**ADDENDUM NO. 1  
WATER MAIN BUILDING  
REQUEST FOR BIDS #11-1753  
October 28, 2010**

OREGON ZOO  
WATER MAIN BUILDING  
PORTLAND, OR

**WATER LINE CONSTRUCTION PROJECT PLAN**  
**THE OREGON ZOO**  
City of Portland, Multnomah County, Oregon

SHEET TITLE  
**PLAN**  
SHEET NUMBER  
**C03**

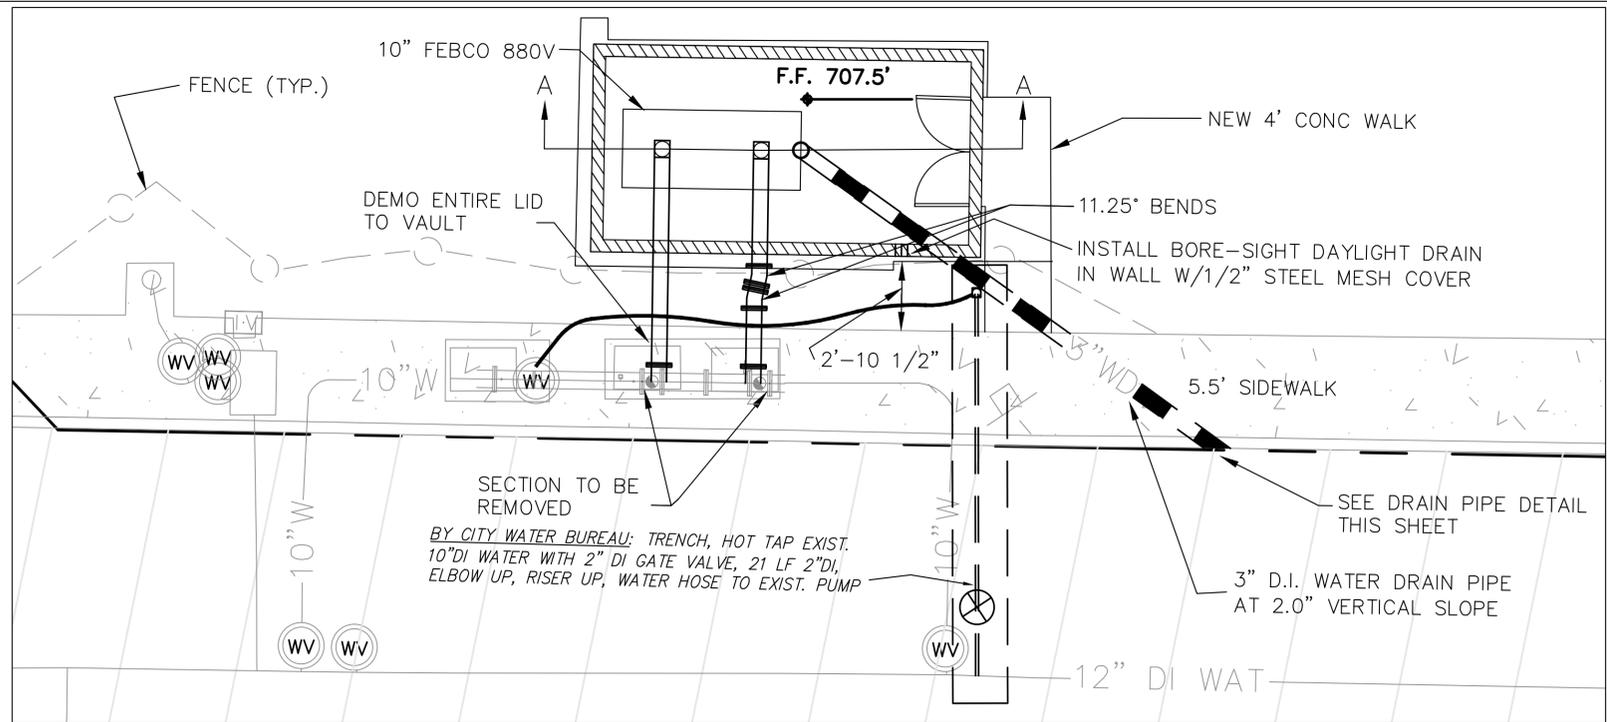
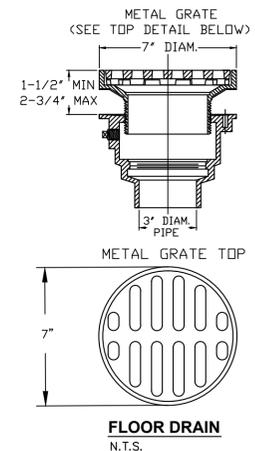
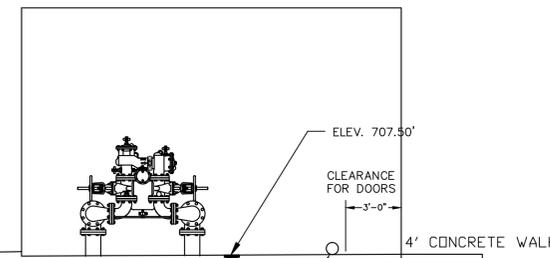
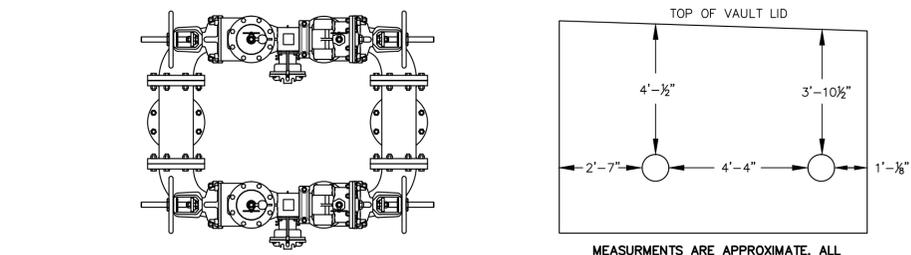
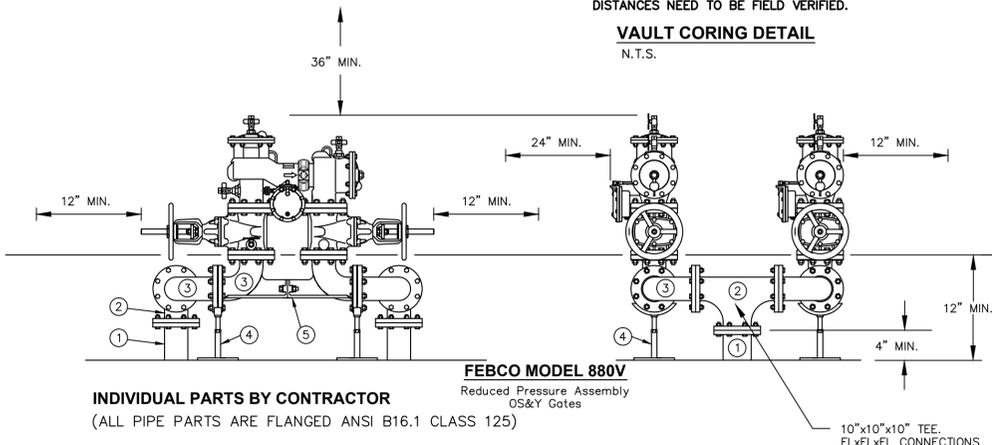
**CLARIFICATION** of shut down and temporary water supply.

**SHEET C03**

**REPLACE** the entire C03 sheet in its entirety. Revise Sheet C03 attached to this Addendum

- NO SHUTDOWN OF WATER SYSTEM TO THE ZOO WILL BE ALLOWED. THE WATER BUREAU WILL PROVIDE A TEMPORARY SERVICE WITH A 2 INCH LINE. CONTRACTOR TO HOOK THE TEMPORARY SERVICE WITH A HOSE PROVIDED BY WATER BUREAU. THE TEMPORARY SERVICE WILL BE LIMITED TO A MAXIMUM OF 6 HOURS IN LENGTH FROM THE HOURS OF 6 PM UNTIL 4 AM. DURING THE RESTRICTED FLOW TEMPORARY SERVICE THE CONTRACTOR WILL PROVIDE 2 3000 GALLON TANKER TRUCKS WITH DRIVERS. ALL OTHER TEMPORARY FIRE PROTECTION WILL BE THE RESPONSIBILITY OF THE ZOO WITH THE EXCEPTION OF THE 2 TANKER TRUCKS.

- SEQUENCE OF CONSTRUCTION TO BE SUBMITTED AND APPROVED. RECOMMEND SEQUENCE TO BE: REMOVE EXISTING VAULT LID; VERIFY DIMENSIONS & GROOVES TO LID AND SUBMIT TO ENGINEER; CORE NEW HOLES (2) INTO N.E. SIDE OF VAULT; INSTALL UNDERGROUND PIPES, FITTINGS, AND CONNECTIONS FROM EXISTING VAULT TO NEW STRUCTURE; CONSTRUCT NEW STRUCTURE; INSTALL NEW DOUBLE CHECK PRESSURE REDUCING ZONE ASSEMBLY WITH ALL REQUIRED PIPING FITTINGS AND SUPPORTS; TEST NEW SYSTEM; COORDINATE WITH CITY ON TEMPORARY BY-PASS SYSTEM; UPON FINAL APPROVAL OF NEW CONNECTION, WORK TO DEMOLISH EXISTING DOUBLE-CHECK AND TIE IN NEW DOUBLE-CHECK PRESSURE REDUCING ZONE ASSEMBLY; TEST WHOLE SYSTEM; INSTALL NEW VAULT LID; COMPLETE SITE IMPROVEMENTS; CLOSE OUT PROJECT.
